STANNAH LIFTS LTD
TECHNICAL BULLETIN

Product : MRLi Passenger Lifts

Subject : Pawl Device Retrofit Kits on lifts with 2 car entrances

TB87 rev A = Change to SRA wiring

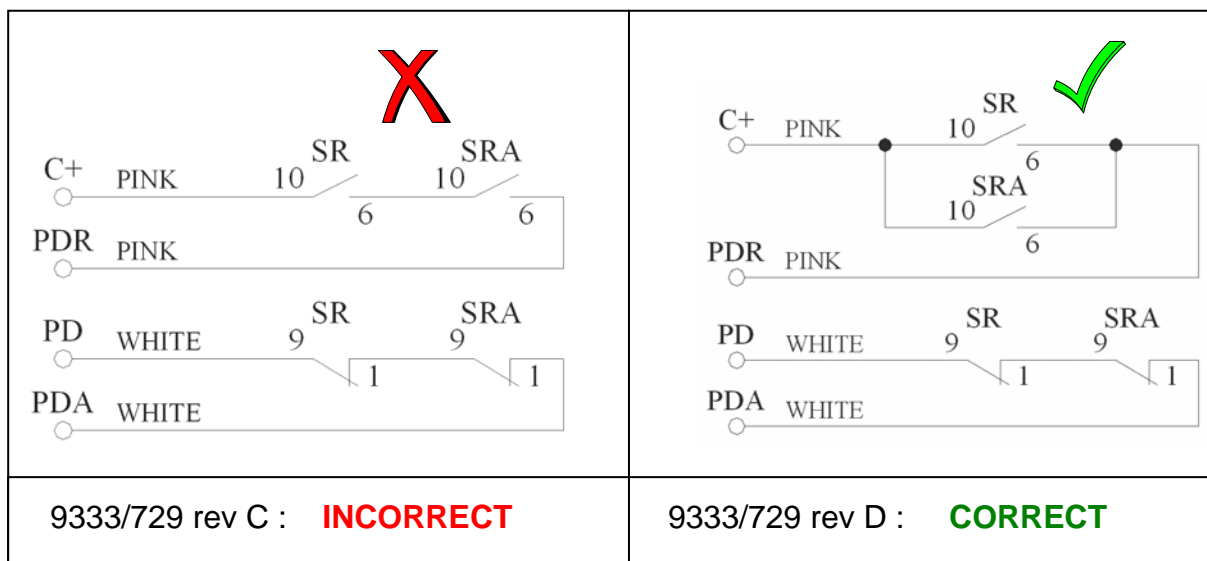
Following the original issue of this bulletin an error has been found on drawing 9333/729 revision C whereby the SRA relay wiring was shown incorrectly (see diagram below).

1. SRA relay on MRLi's with 2 car entrances to be wired in accordance with the above diagram (or 9333/729 revision D or 1009239 rev A).
2. A paper copy of 9333/729 revision D must be stored on site (2 car entrances only).
Earlier revisions of 9333/729 and 1009239 should be discarded.

No extra parts are required - this is a wiring change only.

NAME: S. JACKSON	DATE: 24/03/09
CHECKED: G. COOPER	DATE: 24/03/09
NEXUS ADDITIONAL CIRCUITRY PAWL DEVICE PANEL MODIFICATION DETAILS	
	HEAD OFFICE: Anton Mill Andover Hampshire SP102NX England
Tel: 01264 339090 Fax: 337942	
DRAWING NO: 9333/729	REV: D

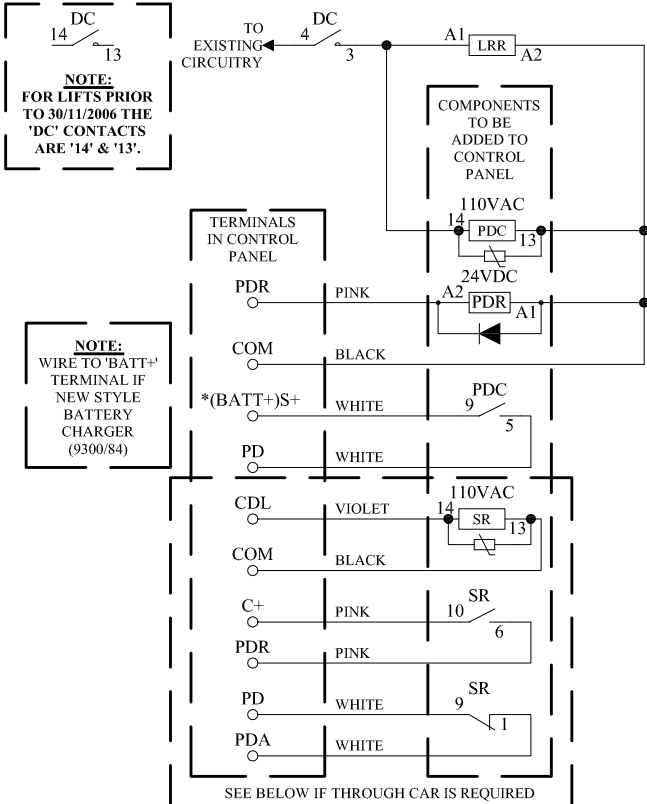
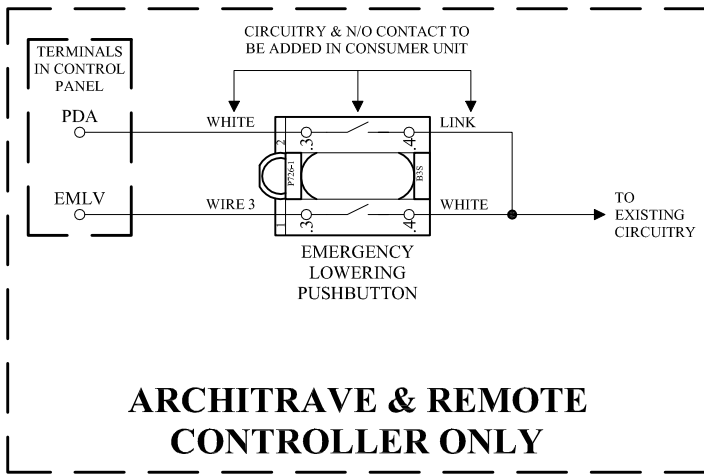
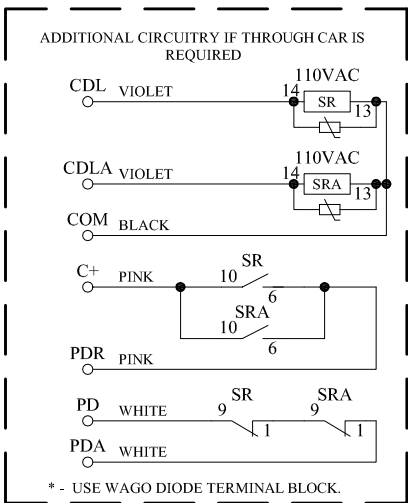
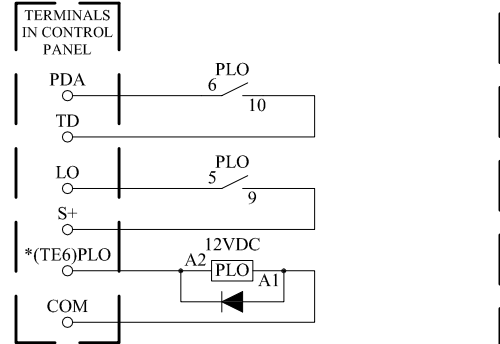
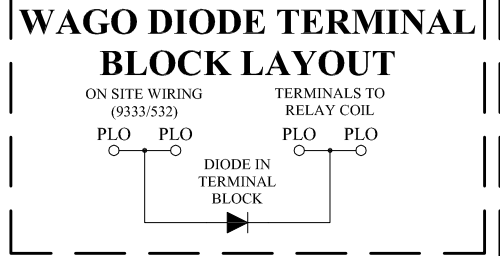
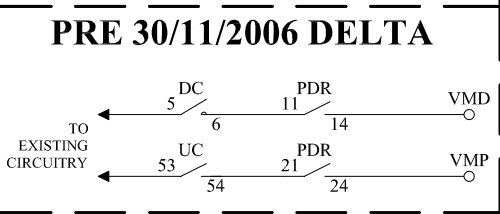
REV D: 'SRA' RELAY CONTACTS '10' & '6' CHANGED TO BE WIRED IN PARALLEL WITH 'SR' CONTACTS '10' & '6'. NOTE ADDED TO 'DC' CONTACTS. 17/11/2009 SAJ.
REV C: DIODE TERMINALS REMOVED. 'SRA' RELAY ADDED 10/11/2009 SAJ.
REV B: 'BATT+' NOTE ADDED. PLO RELAY CONTACT NUMBERING CHANGED 13/10/2009 SAJ.
REV A: LINK BETWEEN 'PDA' & 'TD' REMOVED, NOW WIRED THROUGH 'PLO' RELAY, WAGO DIODE TERMINAL BLOCK LAYOUT ADDED, ALONG WITH ADDITIONAL CIRCUITRY FOR THROUGH CAR 14/09/2009 JN

**NOTE:
ADDITIONAL WAGO TERMINALS
LABELLED 'PDR', 'PDA' & 'PD' REQUIRED.**
